Intel[®] Celeron[®] Processor Specification Update

Release Date: April 02

Document Number: 243748-044

Figure 1 Celeron® on 0.13 Micron Processor 256K Platforms Workaround

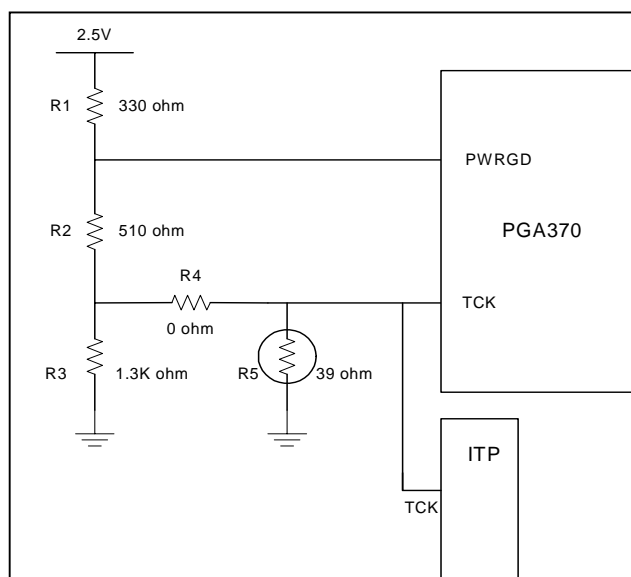
Workaround: To prevent the risk of power-on boot failures or catastrophic thermal failures, a platform workaround is required. The system must provide a rising edge on the TCK signal during the power-on sequence that meets all of the following requirements:

Please note, the example workaround circuits attached require circuit modification for ITP tools to function correctly. These modifications must remove the workaround circuitry from the platform and may cause systems to fail to boot. Review the accompanying notes with each workaround for ITP modification details. If the system fails to boot when using ITP, issuing the ITP 'Reset Target' command on failing systems will reset the system and provide a sufficient rising edge on the TCK pin to ensure proper system boot.

In addition, the example workaround circuits shown do not support production motherboard test methodologies that require the use of the processor JTAG/TAP port. Alternative workaround solutions must be found if such test capability is required.

For Production Boards:
Depopulate R5
